**FIRLOUGH WIND FARM, CO. MAYO
AND
HYDROGEN PLANT, CO. SLIGO**

**SECOND RESPONSE TO THIRD PARTY
SUBMISSIONS
AND OBSERVATIONS
PLANNING APPLICATION REFERENCE
ABP-317560-23**

PROJECT	Firlough Wind Farm and Hydrogen Plant	
CLIENT / JOB NO	Mercury Renewables (Carrowleagh) Limited	6129
DOCUMENT TITLE	Second Response to Submissions Received

SOUNDPLAN L-OPUS/8/01 CHRONOMETER SURVEY (REDACTED) GOVERNMENT OF IRELAND			
Dwg. By	SB	Dwg No.	-
Checked By	SJ	Rev	3
Stage	-	Date	06/03/24
Scale	1:10,000 (A3)	Figure	11.9

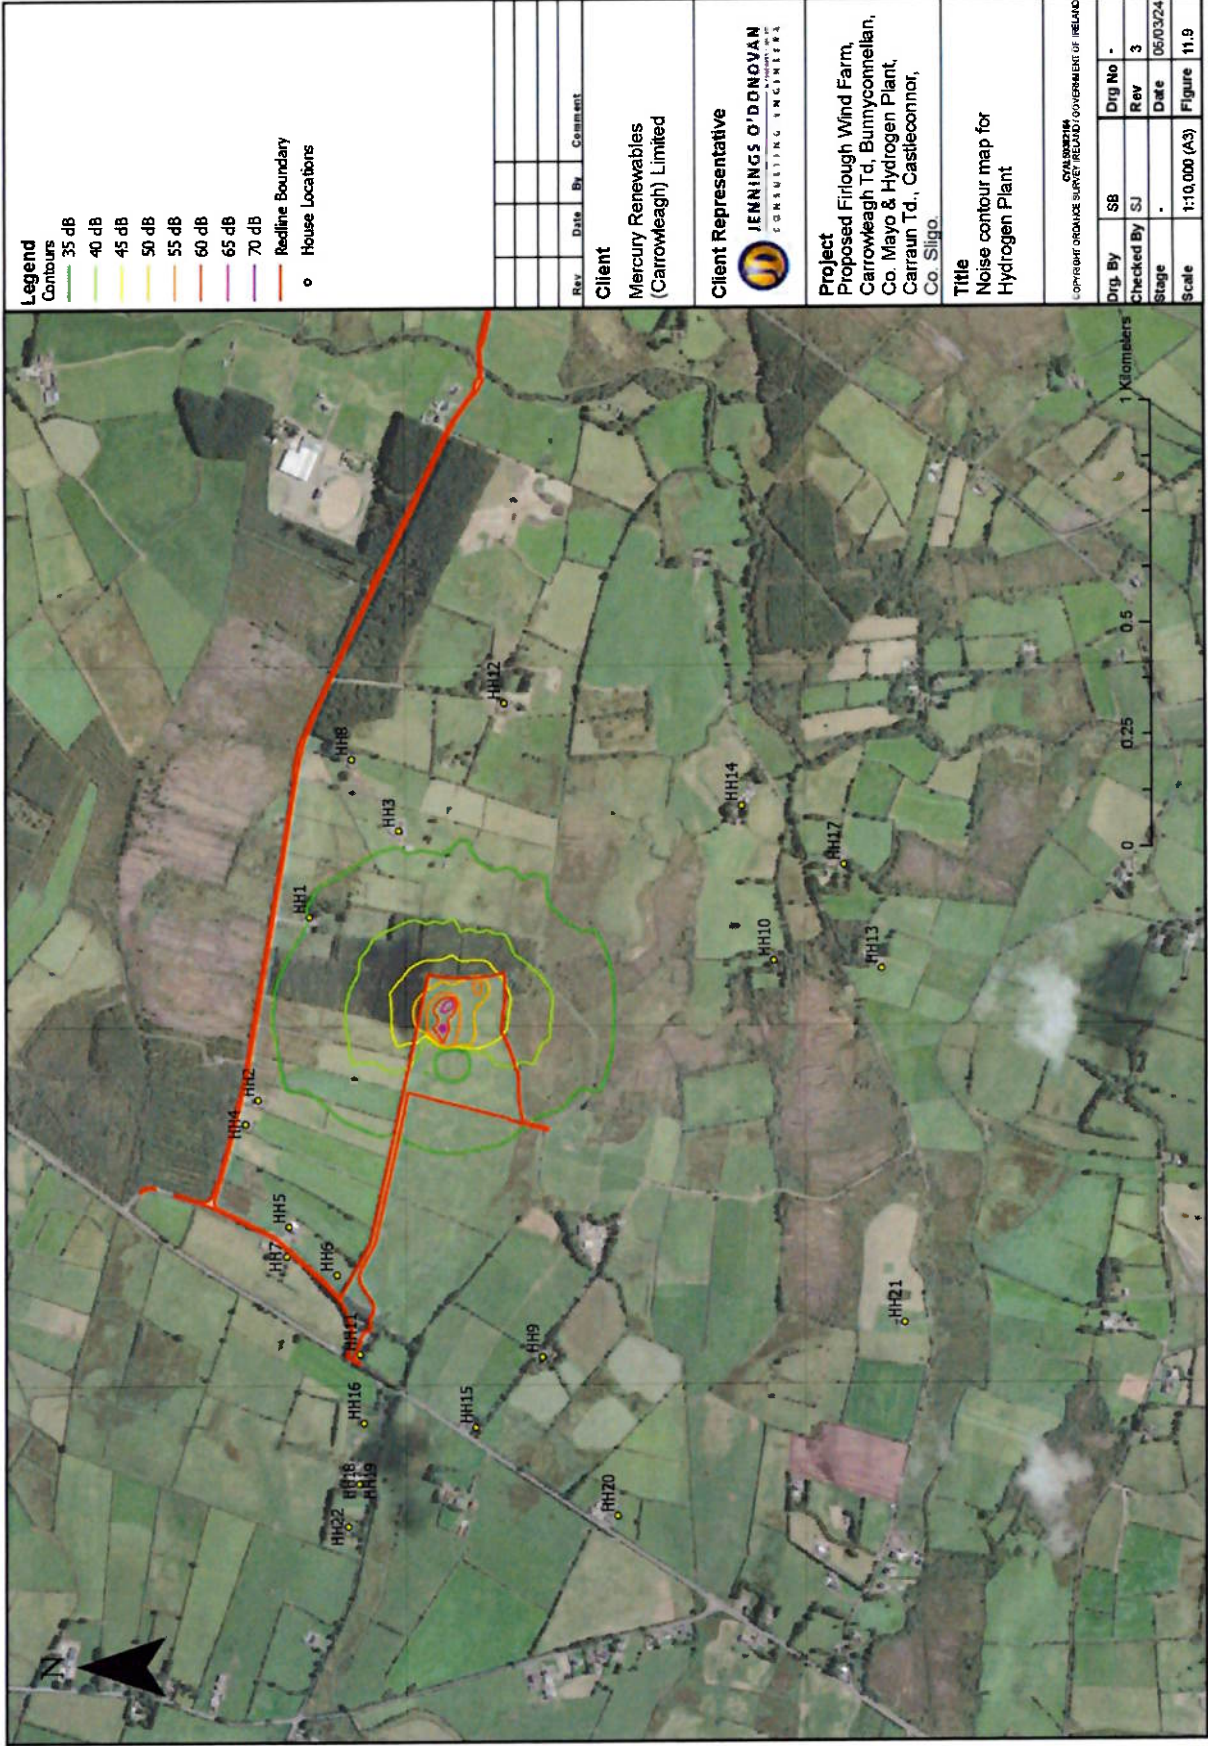
House numbers HH10 and HH13 have been mapped in error approximately 500m west of their correct location. This does not affect the technical assessments. These are both derelict houses and the corrected locations are further from the Hydrogen Plant than the location assessed in Chapter 11 Noise. The noise impacts would therefore be expected to be slightly lower than those identified. The derelict house locations are both well outside the noise contours.

- HH10 was mapped as 600m to the southwest of the Hydrogen Plant, the correct location is 610m to the southeast of the Hydrogen Plant.
- HH13 was mapped 680m to the southwest of the Hydrogen Plant, the correct location is 830m to the southeast of the Hydrogen Plant.

Fin-fan coolers produce 102dBA and the Applicant advises that they have an enclosure that attenuates by 12dB, giving a total of 90dB. Yet the highest noise contour shown on Figure 11.9 is 70dBA. The figure of 102dBA is similar to the noise output of a wind turbine yet if one studies Figure 11.2 (Wind Turbine Noise Contour Map) the noise contours are much more spread out with the best part of half a kilometer between the 45dB and 40dB contours. There appears to be an anomaly in the way these contour maps are modelled.

We also note that our house is omitted from figure 11.9 despite houses being counted that don't exist.

For the avoidance of doubt Figure 1.3 and Figure 11.9 of the EIAR has been updated to include the corrected location of these two derelict houses.

The label for HH19 has been omitted in error on this figure. The house is visible on the figure and the location is far outside the cumulative noise contours. The label has been correctly added in the amended figure in Section 2 of this document. HH19 is included on Figure 1.3; Hydrogen Plant House Location Map. HH19 is assessed throughout Chapter 11; Noise.

Figure 2, Proposed amenity path to MA031-34

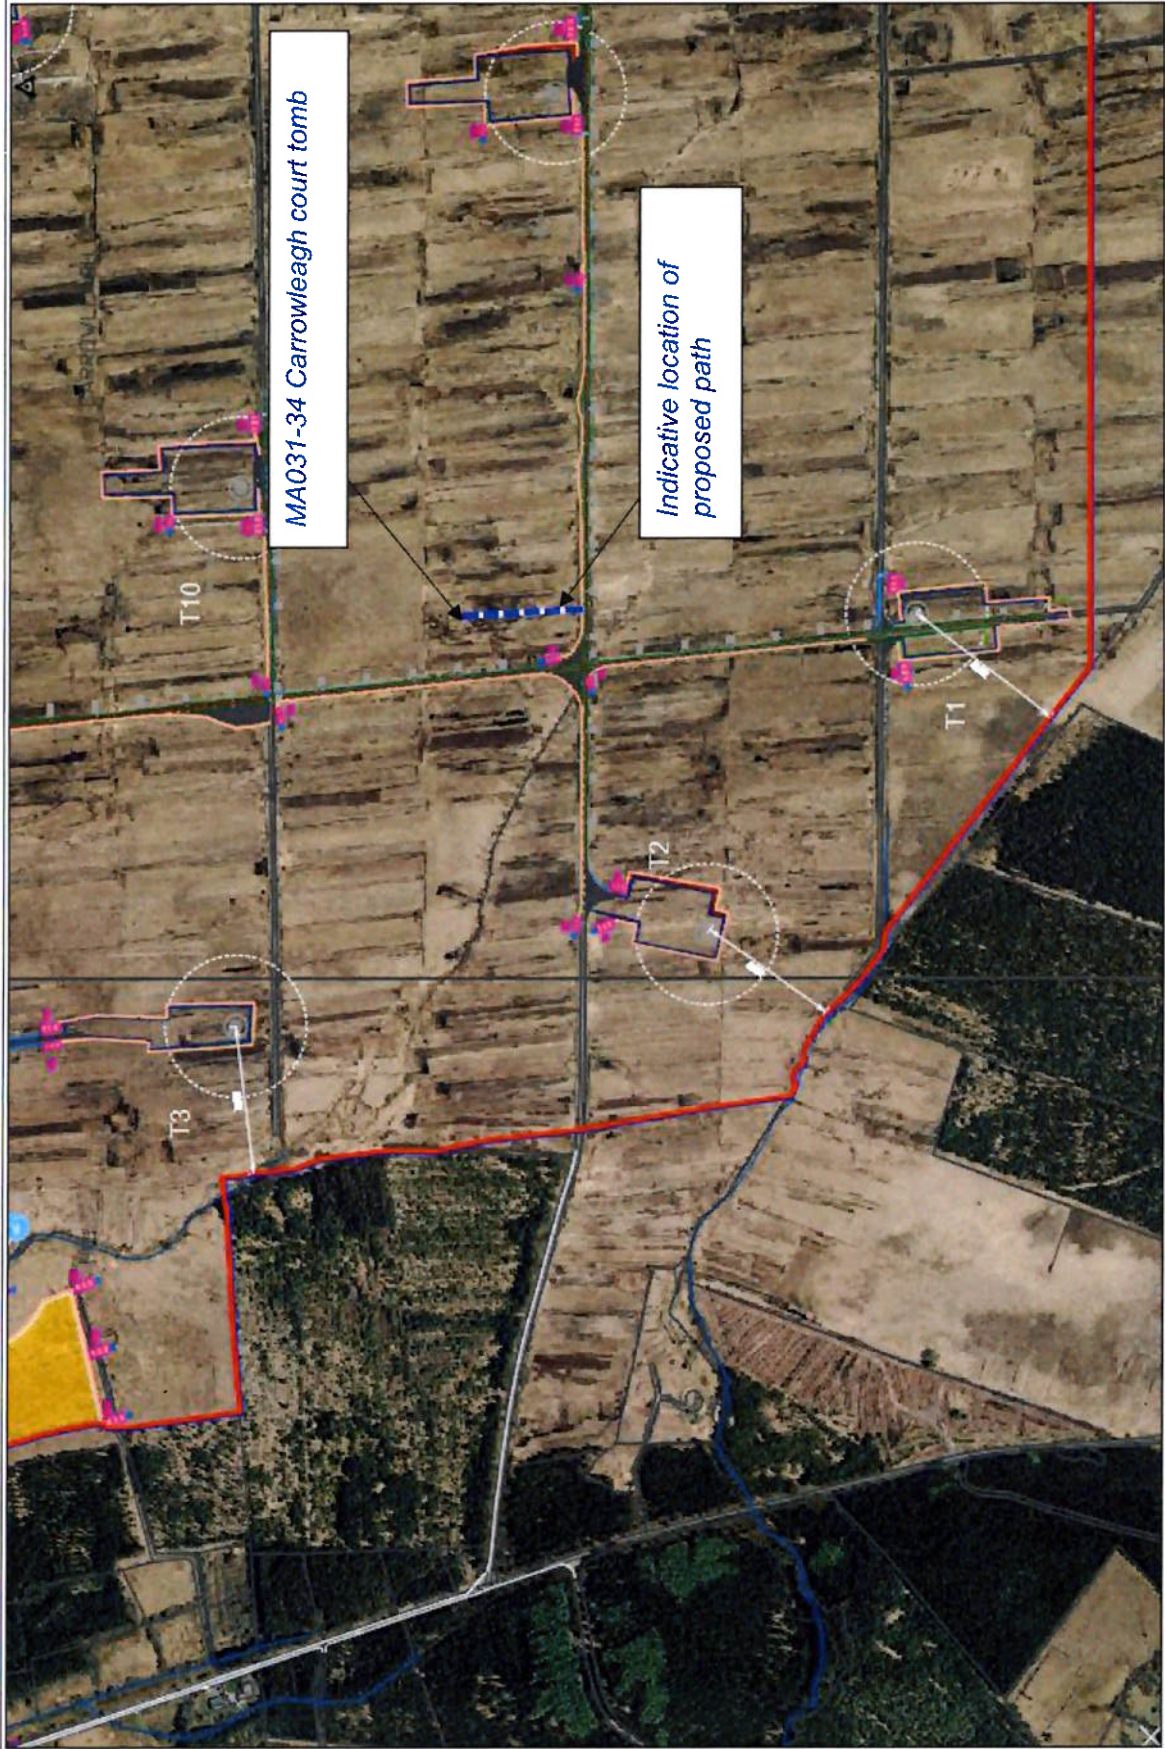
I call on An Bord Pleanála to carry out assessments on MA31-034 and MA31-005 in terms of the link they have with solar alignment.

Thank you for this suggestion, enhancing the accessibility of local cultural heritage features is a wonderful idea. The Developer is in agreement and will undertake to provide a stone path for pedestrian use, suitable for wheelchairs to enable access to MA031-34. This can be positioned so that it avoids areas of peat so no peat removal is needed. Please see indicative location of the proposed in Figure 2.

Figure 3: Zone of Contribution for the Hydrogen Plant.

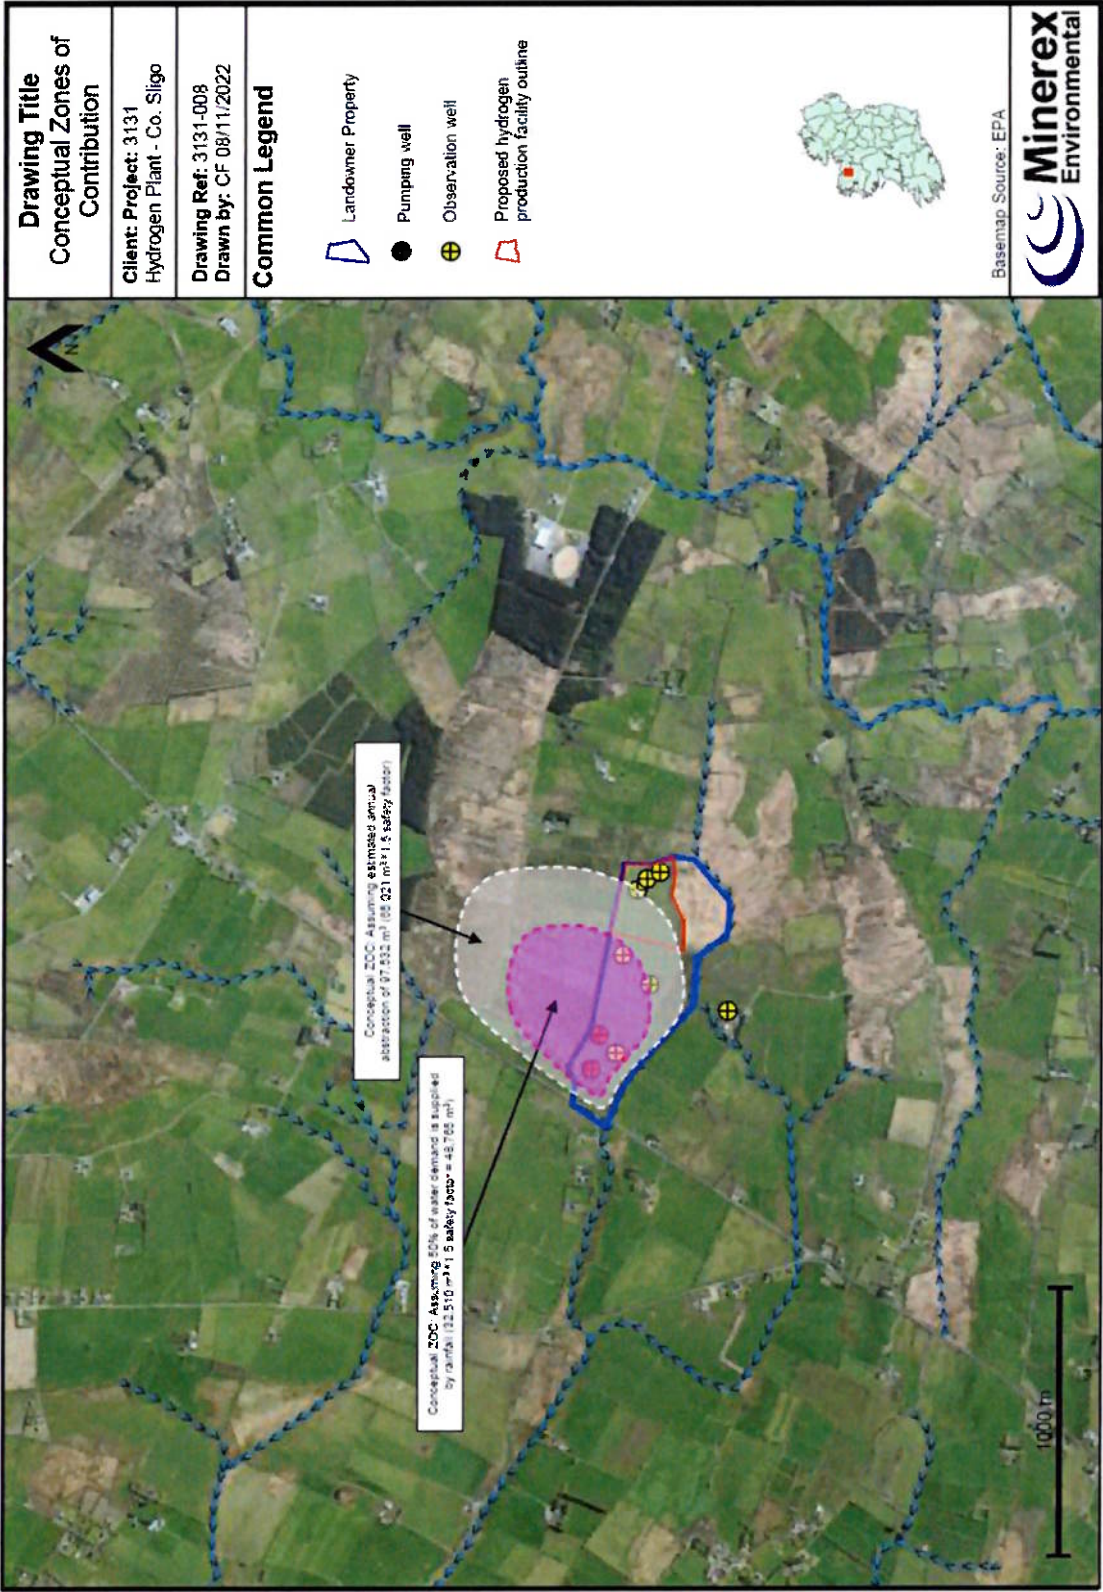
We are not satisfied with the wastewater storage and treatment proposals onsite. I ask if Mercury Renewables got permission from Mayo & Sligo Co. Co. to dispose of thousands of cubic meters of contaminated water into their existing facilities which are already over capacity at their wastewater treatment facilities in Ballina and Enniscrone. Mercury Renewables say it's not practical to put in place a waste water pipeline to these facilities.

Section 5.1.1 of the Submissions Response Document and Section 4 of the Groundwater Supply Assessment in Appendix 9.8, explains the Zone Of Contribution (ZOC) for the water abstractions at the Hydrogen Plant. This is shown below in Figure 3. The depth of the bore holes refers to meter above datum e.g. sea level, this does not imply that the location is in sea water at those depths. The Zone Of Contribution presented below is not considered directly or closely linked to sea water bodies in a hydrogeological context. The Zone Of Contribution is based on sustainable water balance / abstraction rate, and uses conservative data and built in safety factors.

Figure 3: Hydrogen Plant elevations showing re-profiled landscape immediately adjacent

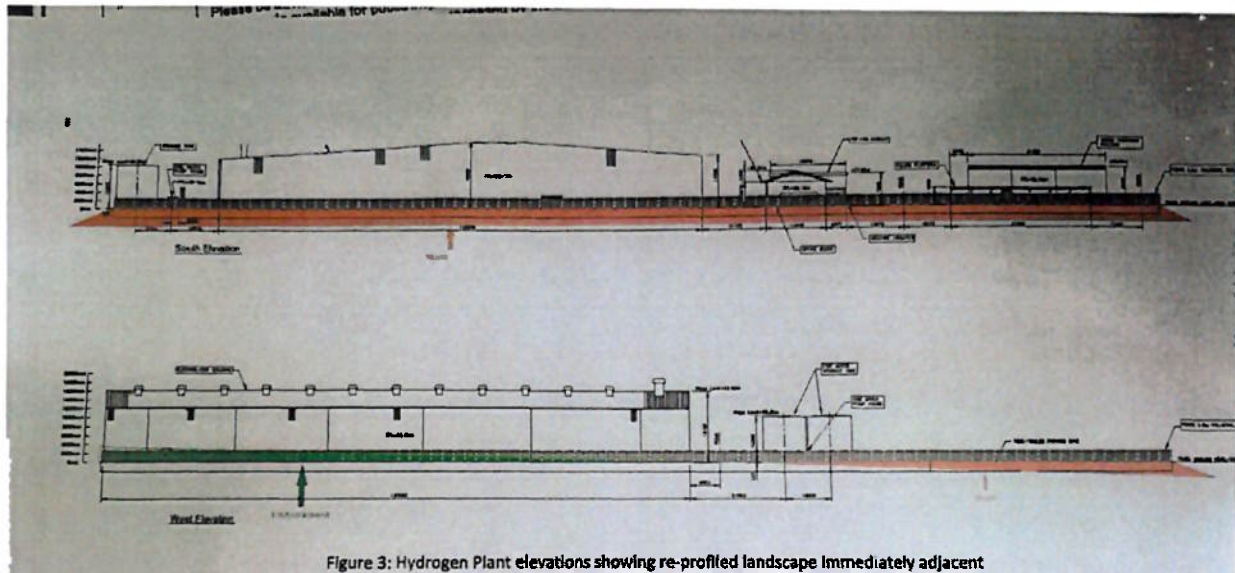
15.1 Chapter 11 paragraph 11.27.42 states: "The noise model accounts for the topography of the existing and proposed land in the vicinity of the site, where it is proposed that the Proposed Development will sit at a lower ground level in comparison to the existing land, where the raised land surrounding the site effectively acts as a barrier. "This is clearly untrue. Drawing 41035-1000- G1000 shows that the site has to be re-profiled, and that the whole of the south elevation is located on a 5m high slope. On the west elevation. The electrolyser plant has a low embankment in front of it, ranging from 3m at its highest point to ground level at the other end of the electrolyser building.

From there, a gradual slope descends some 5m below the plant's finished ground level. 15.2 A rough sketch is shown in Figure 3 below. This is not to scale. 15.3 Compared to the height of the electrolyser building, the low embankment (shown in green) will provide little noise attenuation, whereas the 5m slope (shown in brown) will only exacerbate the noise issue particularly to the south. 15.4 Chapter 11 Table 11.26 provides the output sound power level for site components and Figure 11.9 provides noise contours - presumably dBL Aeq,24h because the plant will run continuously).

Elevation drawings are correct. The existing ground levels of the location of the Hydrogen Plant range from 50m AOD to 53.2m AOD. The finished floor level of the Hydrogen Plant is 50m AOD. See Drawing Nos. 410135-1000-A4000, 410135-1000-A4006 and Figure 2.2 in the EIAR.
